Justification of Flowcharts + phrase

Figure 1: Charging mode configuration for Annex 13

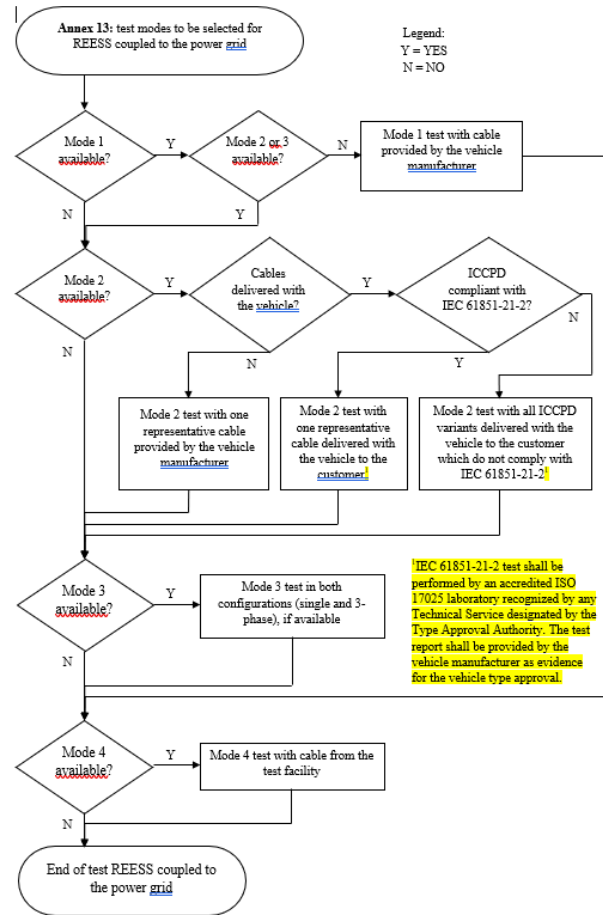
In the opinion of Spain and France, the flow diagrams proposed for Mode 2 charging (CCPD cables) did not respect section 7.1.3 since they proposed not carrying out the tests applicable to all cables supplied by the manufacturer.

This standard has some tests similar to R10, but not all, and also the test conditions are different (**a resistive load is used instead of a vehicle**) to those described in R10, with the vehicle connected, so **the results are not comparable, especially in conducted emission disturbances** (annex 13).

Spain and France did not agree with this from the beginning, but after many conversations and arguments on both sides, a consensus was reached at the IWG, accepting flow charts. but with the condition of the introduction of the described phrase (highlighted in yellow):

The IEC 61851-21-1 test shall be performed by an ISO 17025 accredited laboratory recognized by **ANY** technical service designated by the Type Approval Authority. The vehicle manufacturer will submit the test report as evidence for vehicle type approval. This paragraph is included in the regulations in many places.

For all these reasons, the proposal for flowcharts is complete, flowchart plus sentence, if not, the proposed flowcharts must be deleted completely.
